SUBJECT: FOXTON SOLAR FARM WATERWAY CLASSIFICATION ASSESSMENT

A fast-track resource consent application has been made by Genesis Energy to construct a solar farm near Foxton (APP-2025205573.00). There are a number of watercourses located onsite that the applicant has described as artificial farm drainage canals. I visited the site on 28 April 2026 to undertake a stream classification assessment, with specific regard to differentiating whether these waterbodies are artificial or modified in nature.

Figure 1. The locations of the watercourses onsite. Sourced from Appendix I of the application, the Ecological Impact Assessment

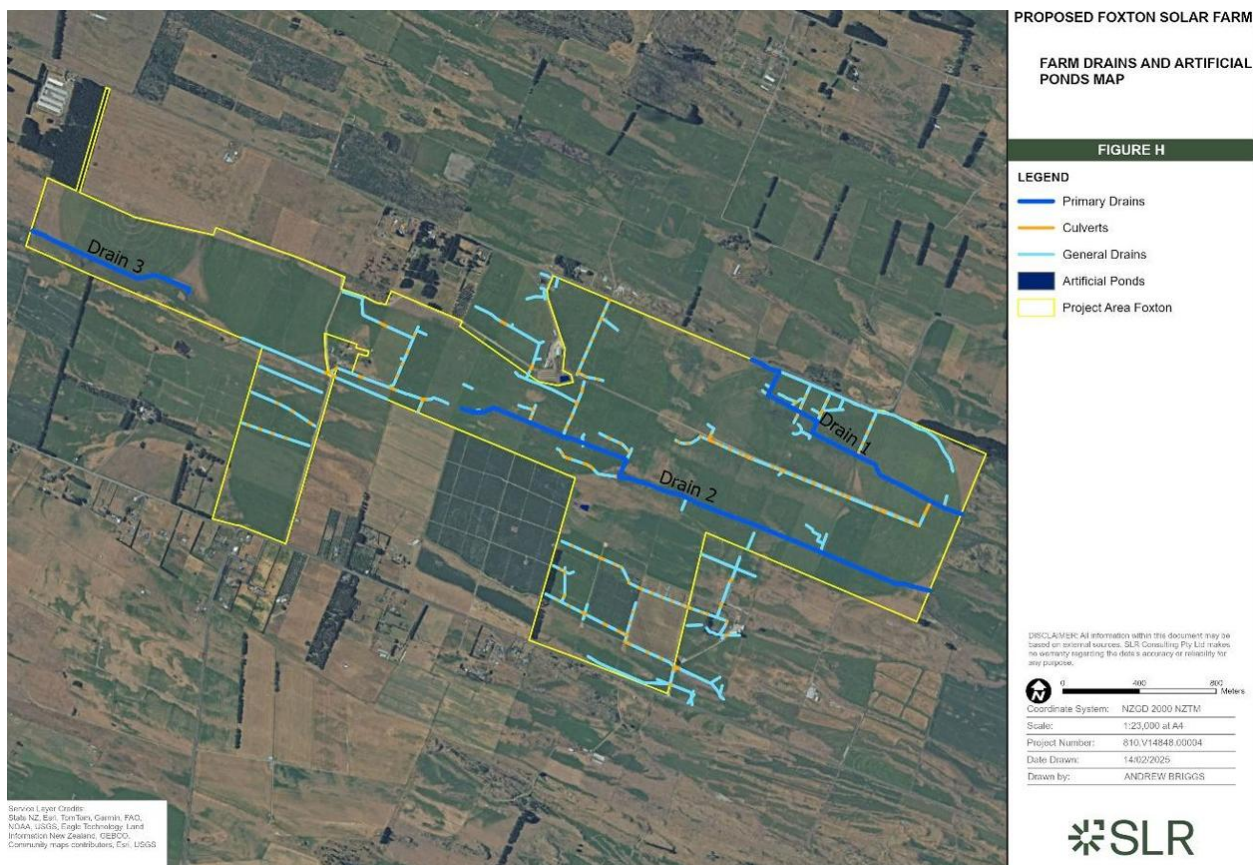
Numerous channels are located across the proposed solar farm site (Figure 1). The three main 'drains' identified by the applicant are assessed in full. The remaining smaller channels observed are grouped together and described collectively.

The conclusions summarised above differ from those of the applicant, who classified all of the channels on site as artificial farm drainage canals. However, it is key to note that this difference in conclusion stems from a matter of interpretation only. Both parties agree that these channels are likely replacing historic wetland extent, with the Ecological Impact Assessment (Appendix I) stating that: *“The drains on the site are most likely to exist to drain wetlands that are likely to have historically been present.”*

There are a number of watercourses located within the proposed Foxton Solar Farm Project Area. The watercourses I observed during a site visit made on 28 April 2026 meet the criteria of modified waterways and therefore meet the definition of a river under the Resource Management Act 1991.
